S E R V I C E N O T E

E4401B, E4402B, E4403B, E4404B, E4405B, E4407B, E4408B, and E4411B ESA Spectrum Analyzer family. Also E7401A, E7402A, E7403A, E7404A, and E7405A EMC Pre-Compliance Analyzers.

Intermittent screen "flicker" due to a cold solder joint

Figure 1

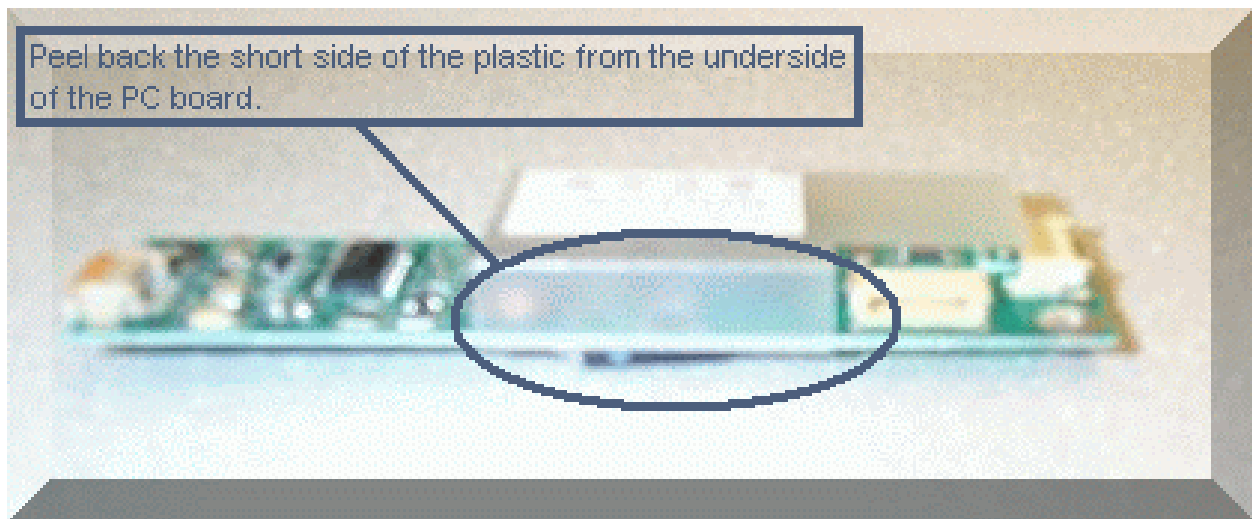
- 1) Peel back the plastic shield on the backlight inverter board. See Figure 1.

Figure 2

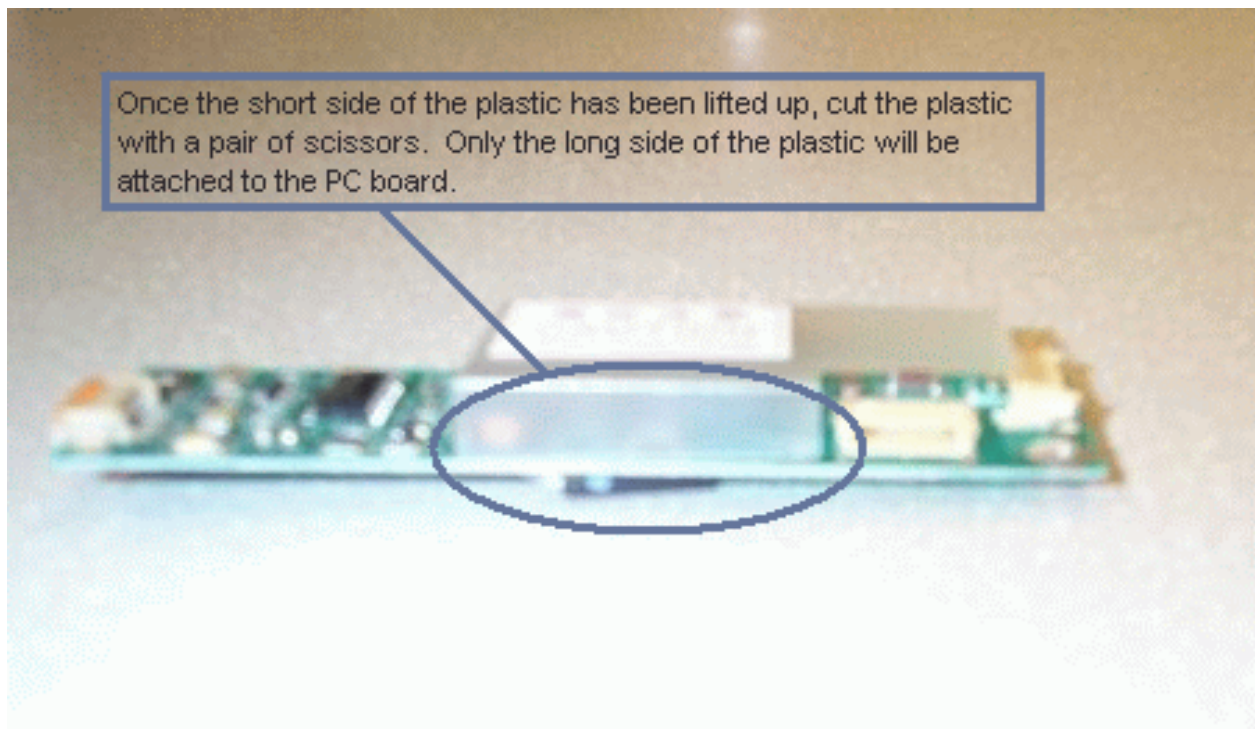
- 2) Cut the plastic with a pair of scissors. See Figure 2.

Figure 3

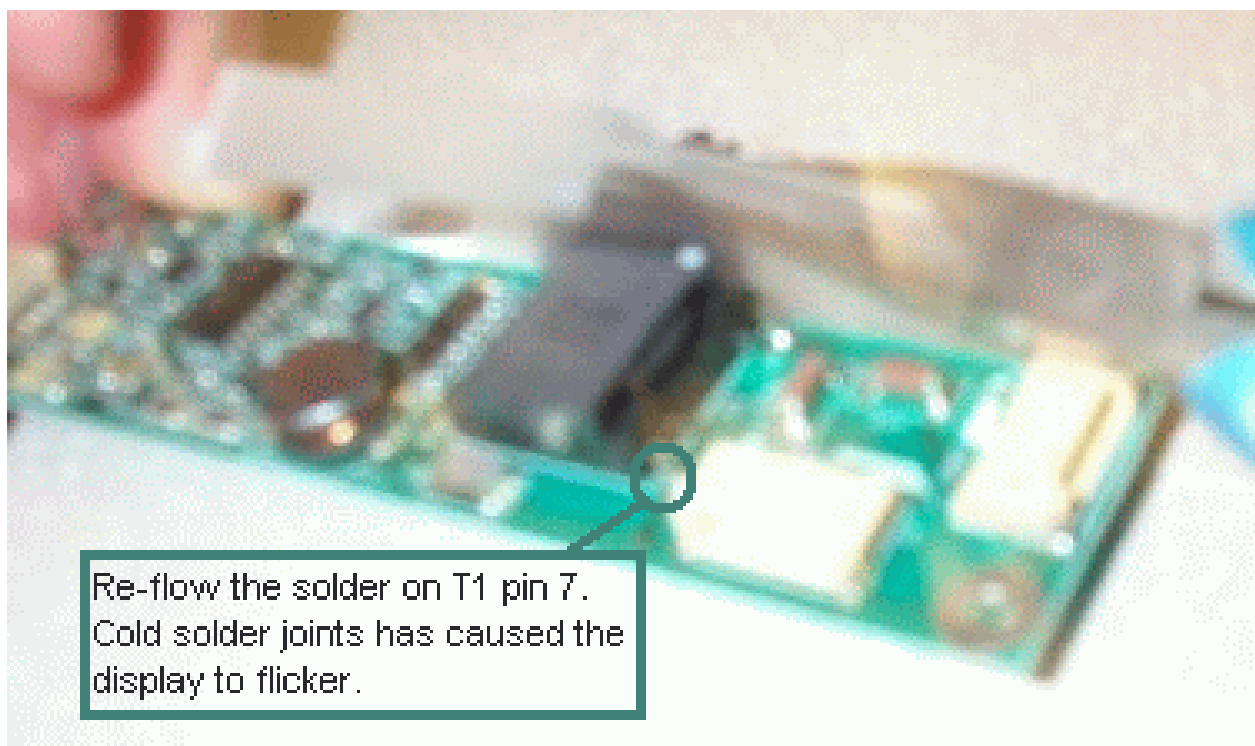
3) Re-solder pin 7 of the transformer on the backlight inverter board. See Figure 3.
